CITY OF WEST DES MOINES
STAFF REPORT COMMUNICATION

ITEM: Fairmeadows Elementary, 807 23rd Street – Approve Major Modification to Site Plan to allow Building Addition and Parking Lot updates – West Des Moines Community Schools – MaM-005328-2021

Resolution: Approval of Major Modification to Site Plan

C200

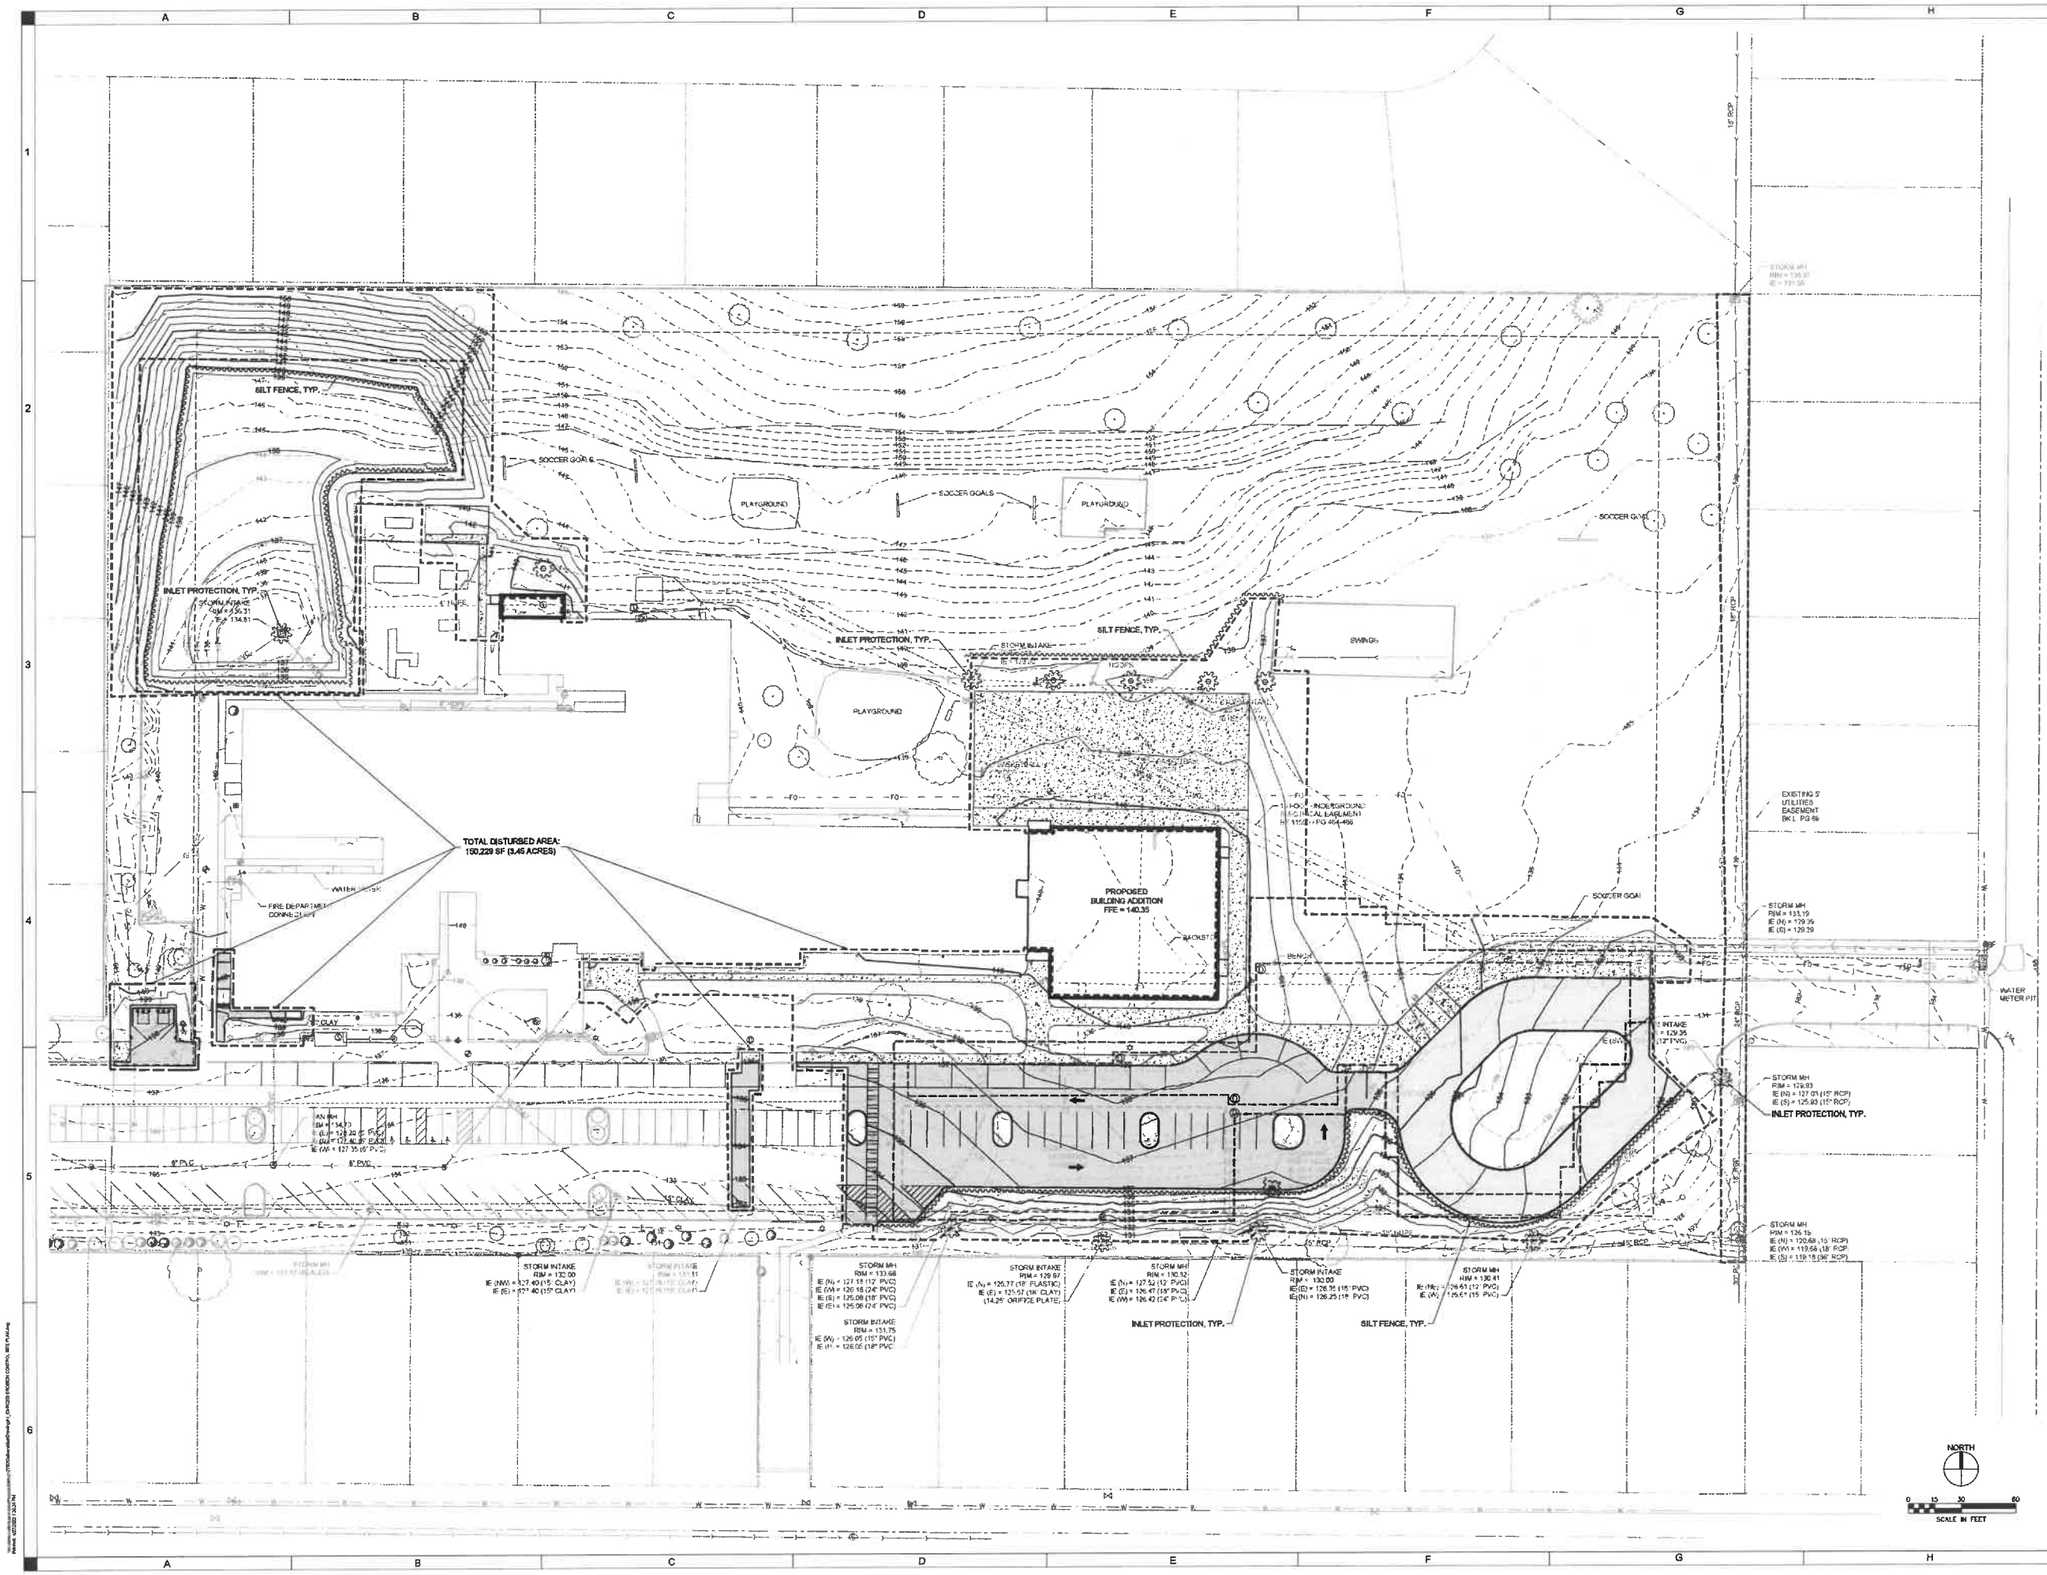
- *Storm Water Management Agreement.* There is on-site storm water detention area that requires an agreement with the city relating to how it is maintained. The Storm Water Management Facility Maintenance Agreement is scheduled to go before the West Des Moines School Board on May 9, 2022. Therefore, staff is recommending a condition of approval requiring the Agreement be executed by the School Board and approved and accepted by the City Council prior to the issuance of any building permits for the building additions. Additionally, staff is recommending a condition of approval that as-builts of the storm water improvements be provided prior to any occupancy, including temporary occupancy.

GENERAL NOTE:
FINAL AS-BUILTS FOR THE DETENTION BASIN WILL NEED TO BE PROVIDED TO THE CITY OF WEST DES MOINES PRIOR TO ANY OCCUPANCY

L101

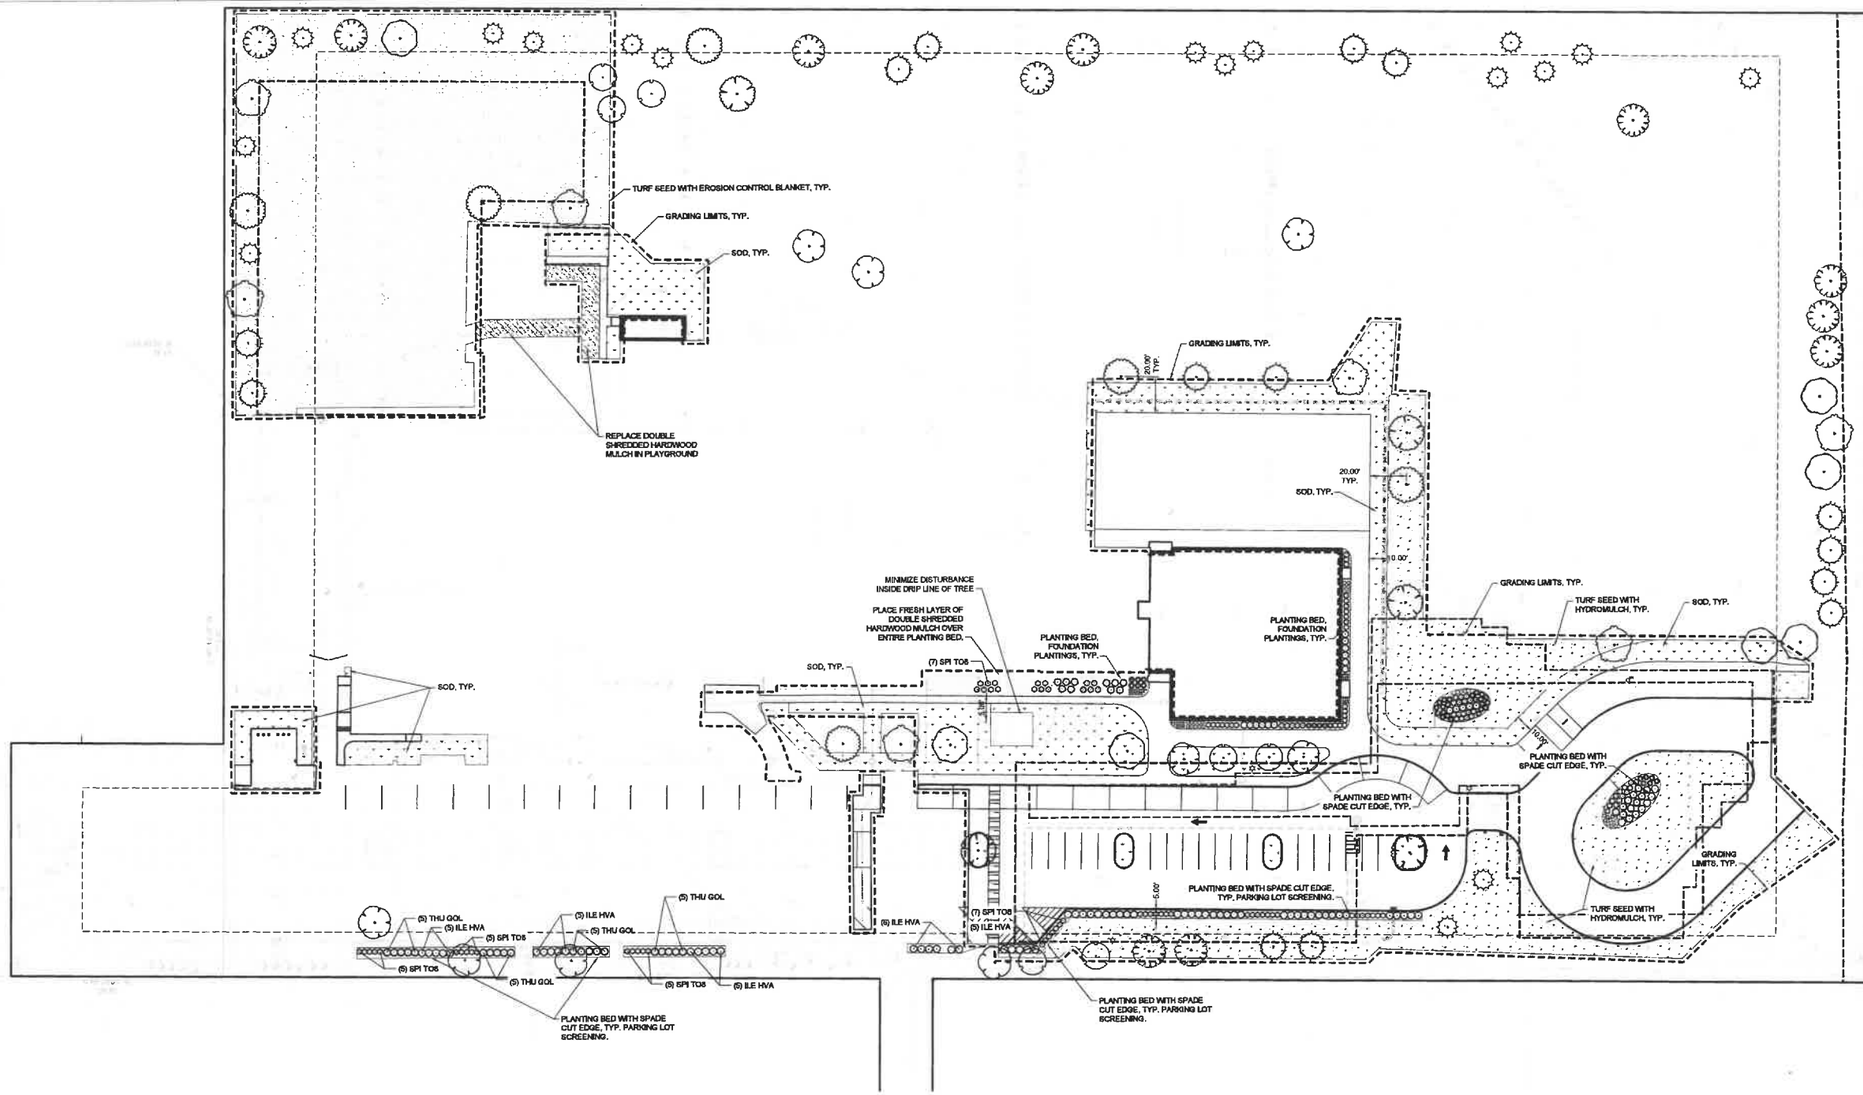
- *Conditions of Approval:*
  - *Alternative Landscaping Plan.* The applicant is proposing to expand the existing parking area to the east. The zoning code requires landscape islands be installed every eighteen (18) parking spaces and tree diamonds every nine (9) parking spaces. These landscaping islands and diamonds are also required by the zoning code to include vegetative plantings to provide visual relief from large expanses of parking and provide shade. There are twenty-four (24) additional parking spaces proposed as part of this development that would require one landscape island and two tree pods. However, there is an existing underground storm water detention system beneath the proposed parking expansion, which would make it difficult for vegetation to thrive within the landscape islands and pods. The applicant is requesting approval of an alternative landscape plan which includes relocating the required parking lot plantings (i.e. trees and shrubs) outside the underground storm water detention system and installing landscape islands where pods would be required. As part of this alternative landscape plan, the applicant is also

proposing more trees than required by code within the interior of the site and along the property line to the south to further screen the school from adjacent residential uses. The landscape islands within the parking area will be sodded greenspace. Staff is recommending a condition of approval confirming Council acceptance of this alternative landscape plan.

1. The City Council approving the alternative landscape plan as proposed by the applicant.
2. All easements benefitted to the City shall be executed by the School Board and approved and accepted by the City Council prior to the issuance of any building permits for the building additions.
3. The Storm Water Management Facility Maintenance Agreement be executed by the School Board and approved and accepted by the City Council prior to the issuance of any building permits for the building additions. Additionally, the applicant providing as-built drawings of the storm water improvements prior to the issuance of any occupancy permit, including temporary occupancy.
